MEMORANDUM

TO: Hal Cohen, VT DPS
FROM: Mark Kane
CC:
DATE: April 16, 2018
RE: Gilman Landfill Solar – PUC Docket

Figure 1 - Inadvertent Clearing Areas - Gilman Landfill Solar

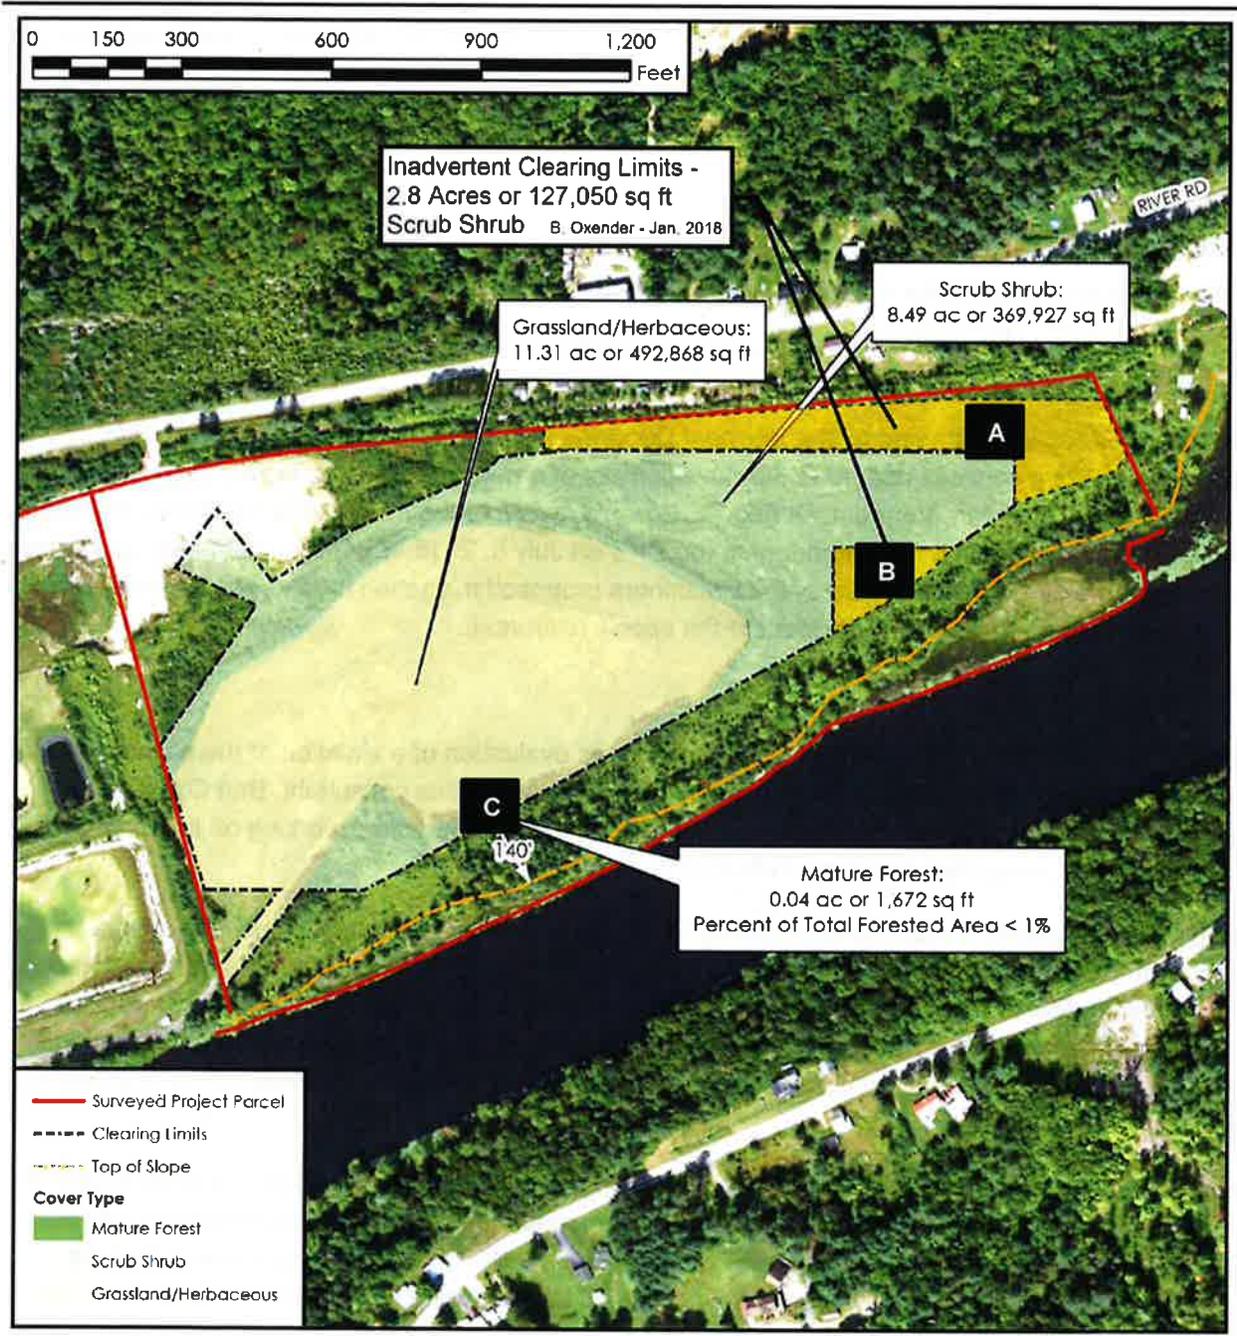
The largest of the areas inadvertently cleared was along the Project sites frontage with River Road. At about 2.3 acres, this area ("Cleared Area A"), was composed of mostly successional shrubs with some inclusions of small trees and conifers. These natural planting did contribute to the screening of the Project from River Road and a few residential properties that separate the Project site from the roadway.

Two smaller areas of inadvertent clearing were disclosed by Petitioner; one to the north of the proposed array ("Cleared Area B") and a very small area to the east ("Cleared Area C"). These cleared areas are about 0.52 acres and 0.04 acres respectively. A plan, prepared by the Petitioner, showing these areas is included on the following page.

In evaluating the potential impact of these clearing areas on my original conclusions, I make a distinction between each of them. The impact of the clearing from Clearing Area B and Clearing Area C are not consequential relative to the concerns I had expressed in 2016. Clearing Area B does little to intervene between the Project site and offsite vantage points to the west. Clearing Area C is nominal in size. Clearing Area A, however, is more substantial to the screening of the Project. Its absence introduces more exposure of the Project from vantage points along River Road and nearby residential properties.
